8495B-02

Modification Recommended Service Note

8495B – Manual Step Attenuator

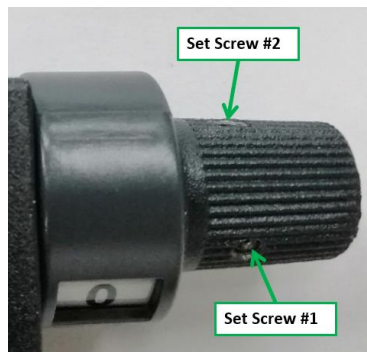
The attenuation knob was not securely tightened to the internal shaft, causing it to turn further. This is due to an insufficient torque that was applied to tighten the set screw during assembly at the factory.

This issue can be fixed by re-tightening the screws on the rotating knob.

- (1) Rotate the knob clockwise until it reaches the last attenuation step, which is at 0 dB.
- (2) Loosen the 2 set screws (0.05" Hex screw bit) on the knob slightly until the knob can freely move, and then align the knob so that the indicator label number "0" is located at center on dial cover window.

- (3) Tighten both set screws with a 0.05" Hex screw bit and 4.0in-lbs torque driver.

(4) After tightening both set screws, rotate knob counter-clockwise until it reaches the maximum attenuation (11/70/110dB). To ensure the attenuator functions properly, rotate the knob clockwise back to minimum attenuation (0dB), and repeat the movement for 10 cycles.
